TECHNICAL SERVICE BULLETIN

Torque Converter Shudder

26-2341
22 July 2026

Ford 2019-2024 Edge	Transmission: 8F35
Lincoln 2019-2023 Nautilus	Transmission: 8F35

Figure 1 - IDS/FDRS - Shudder event reading

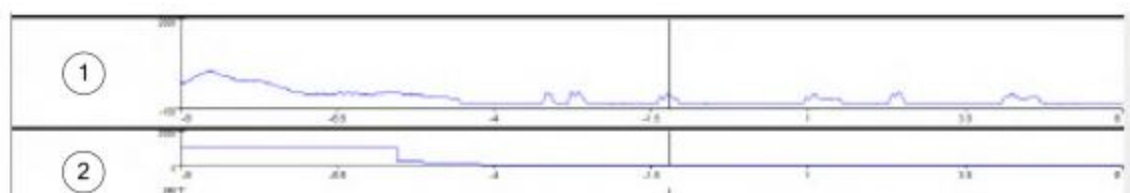
- Shudder condition, most noticeable at speeds below 60 mph (100 km/h).
- No relevant DTCs present.
- Traceable shudder event with IDS/ FDRS reading. Refer to Figure 1.
